CERTIFICATE OF APPROPRIATENESS PLACARD

501 CUTLER STREET

153-16-MW

Raleigh Historic Development Commission – Certificate of Appropriateness (COA) Application

Door # 1

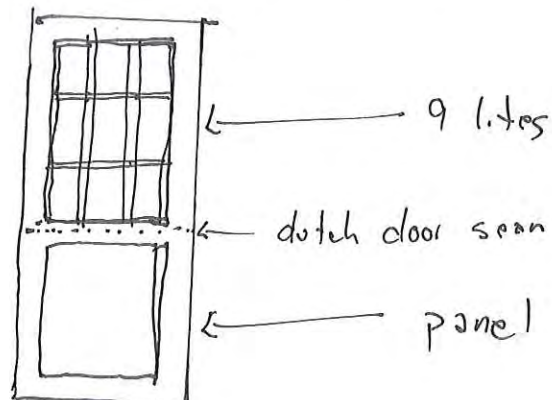
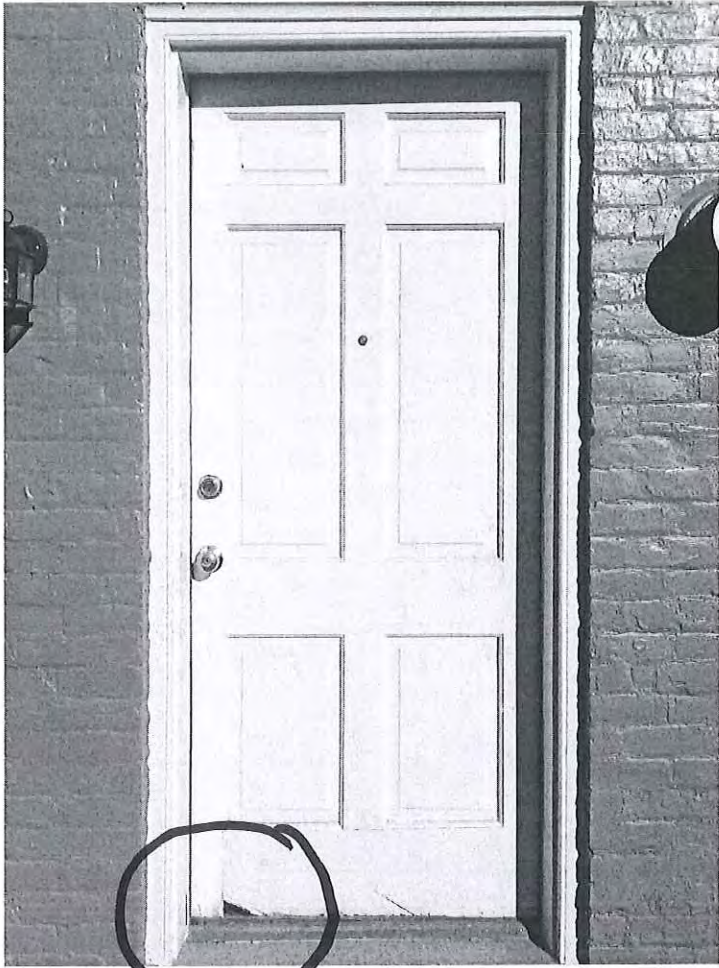
staff sketch

- opaque glass does not meet GL
- ~~one~~ full glass not appropriate

Before Gutters

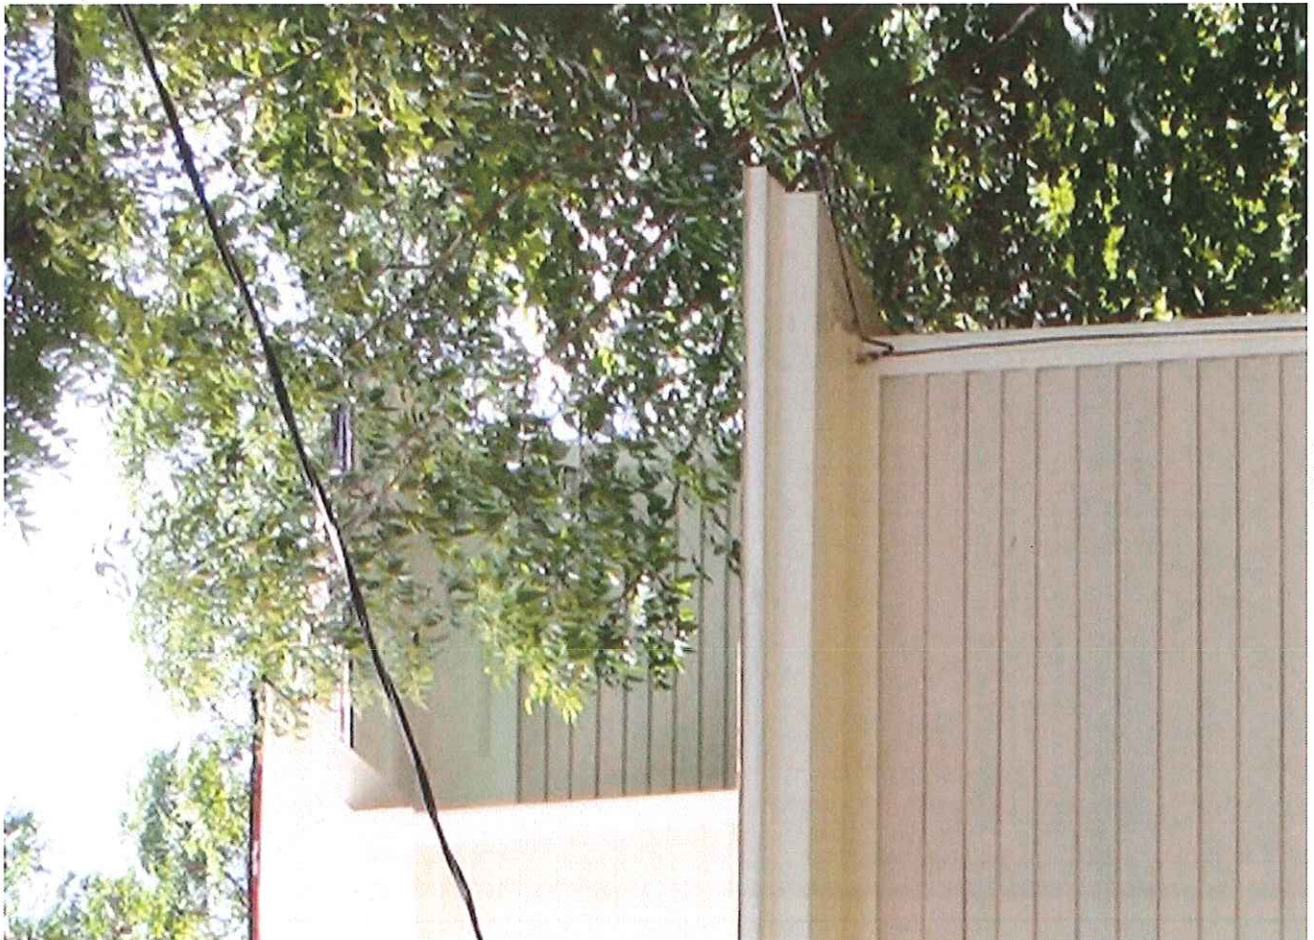
1. Please provide specs for the proposed new doors to supplement the photos.
2. Will the new Red Maple trees be going in the same location as the trees being removed?
3. Is the gutter request after-the-fact? If so, please provide "before" photos.
4. Are the gutters and downspouts metal?

1. We don't have specs for the new doors because they are odd dimensions and will need to be custom built. They will be made of wood and glass.
2. The Red Maples will not be going in the same place. They will be going in a different location in the front yard. We have already obtained a permit to place them in the space between the sidewalk and the street.
3. Due to sever water damage in the base,net, we added the gutters immediately upon moving in, so we don't have a lot of before pictures, but you can see the attached photos for what we do have.
4. The gutters and downspouts are aluminum. -dc

BOM 2008, PG 1487

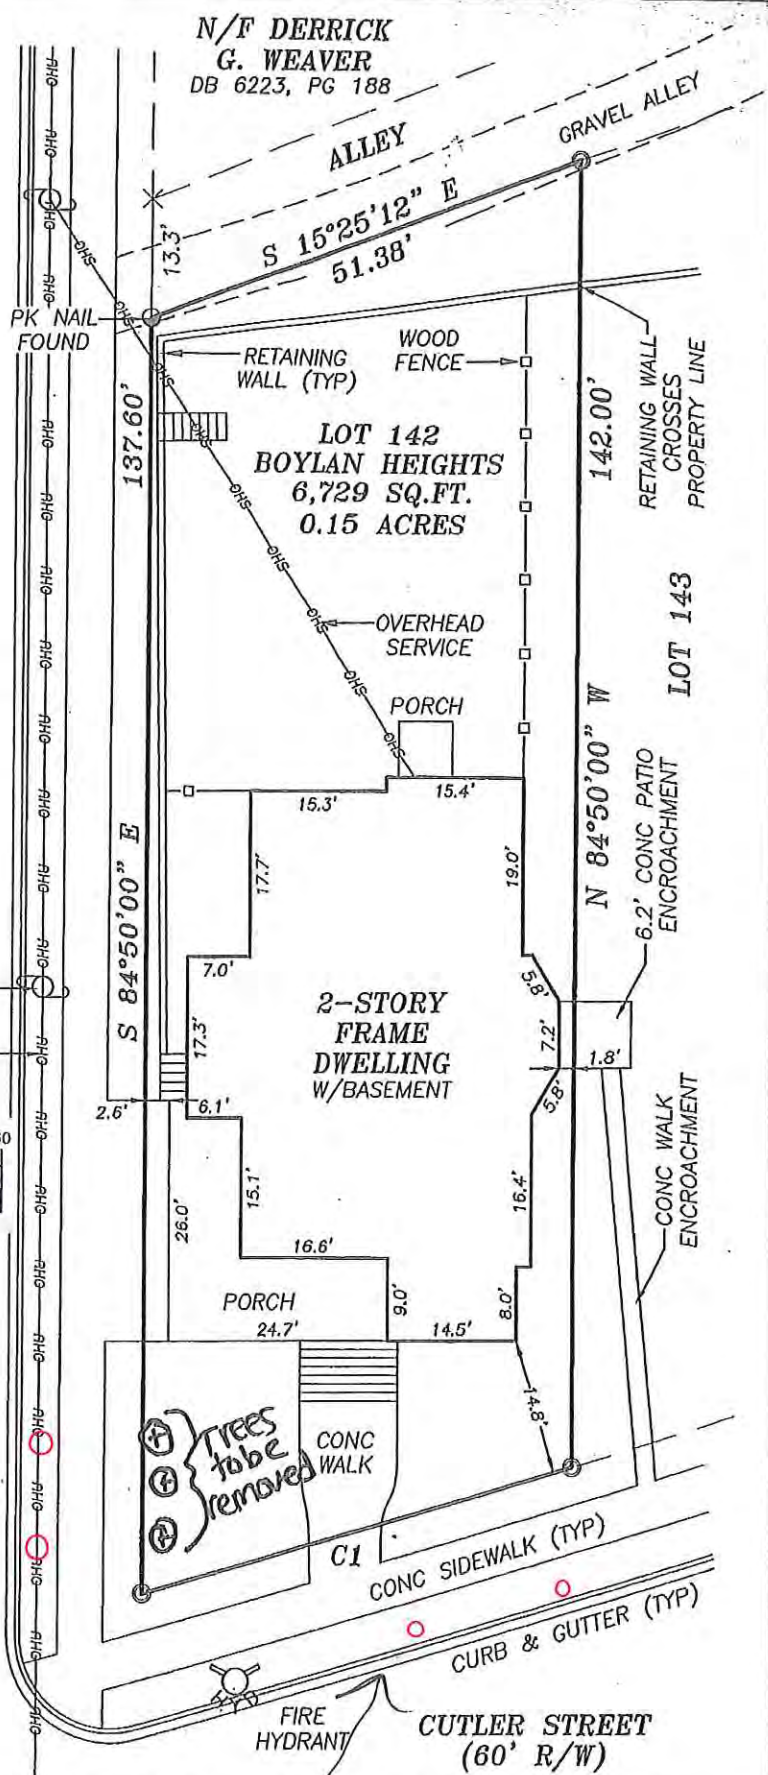
Either describe or mark on here the locations of the replacement trees.

1. This looks correct.
2. We would have 3/4 light on the door.
3. See attached plans for tree placement. It is in the Burkert Plans file. They are marked with red circles.
4. Great!
5. See attached plans for rear drainage. It is in the file DSTR-BRKRT.

Replacement Door #1
Rear of House

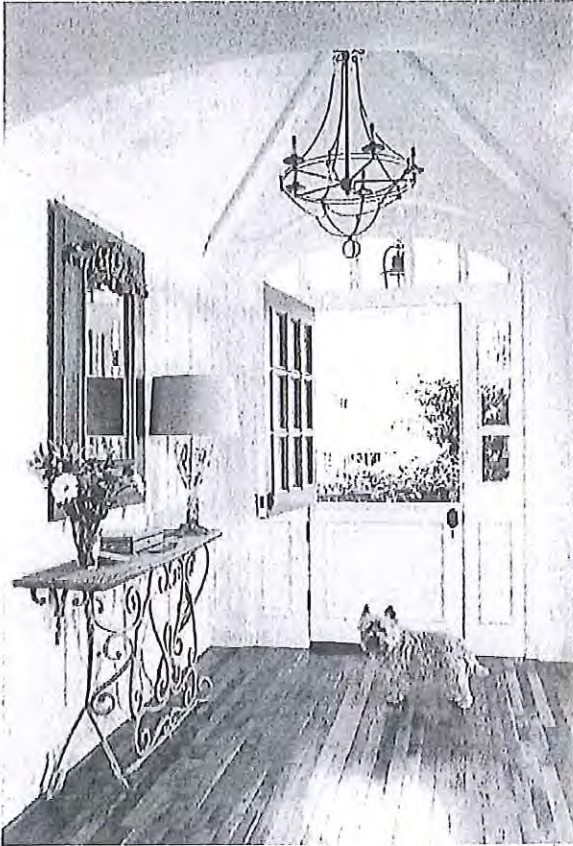
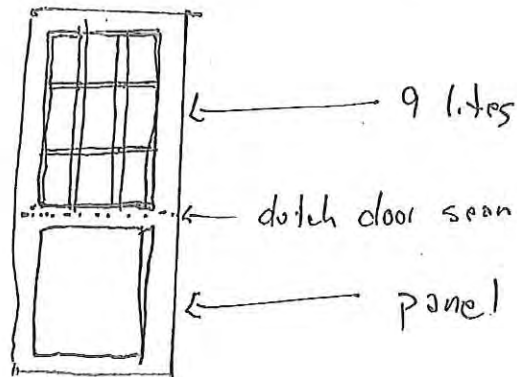
staff sketch

* note in your response confirmation of this design.

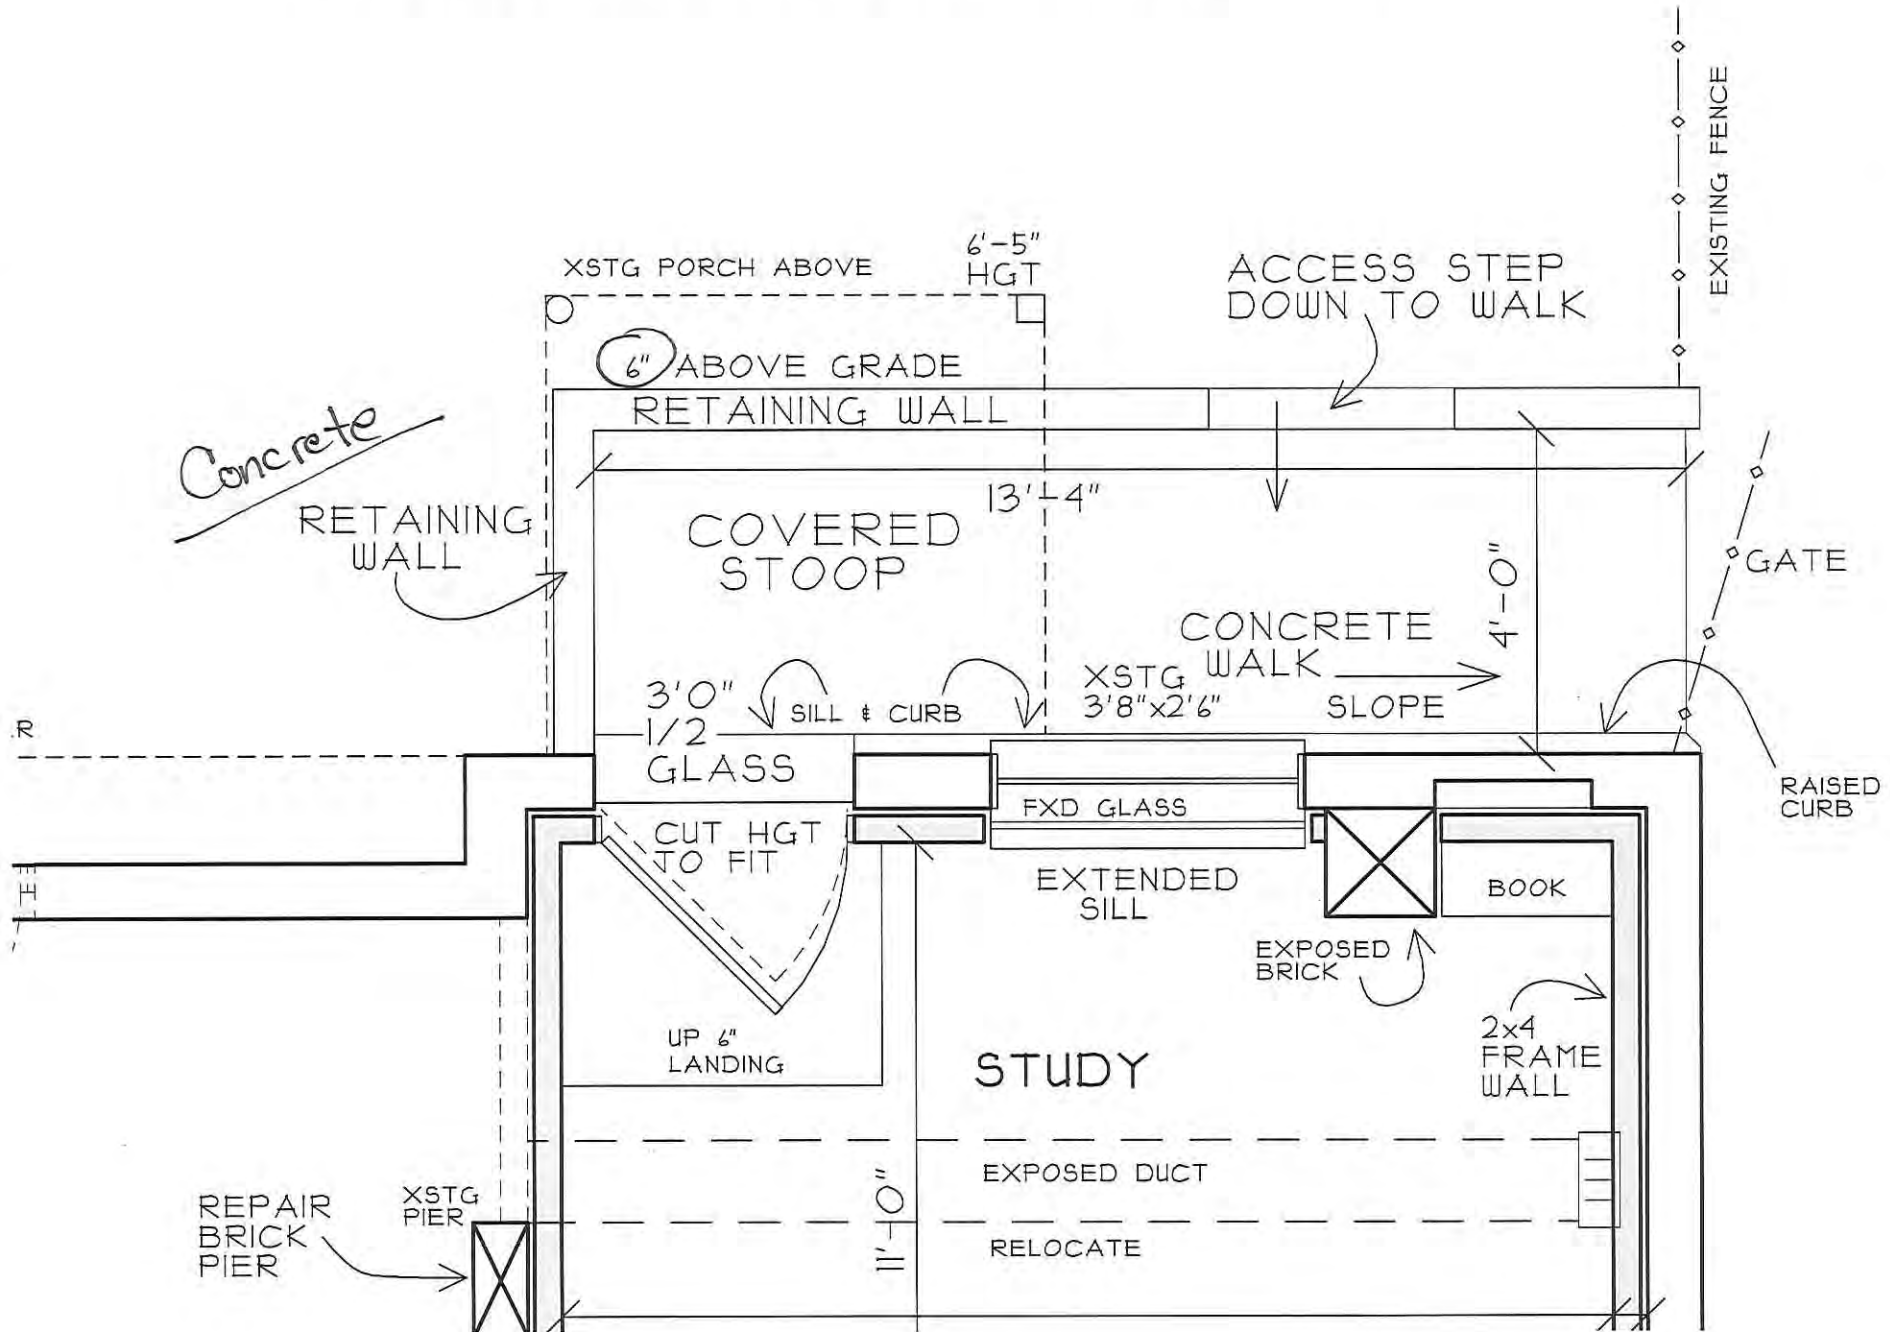
- opaque glass does not meet GL
- ~~one~~ full glass not appropriate

★ Note in your response the proportion of lower panel to glass you select
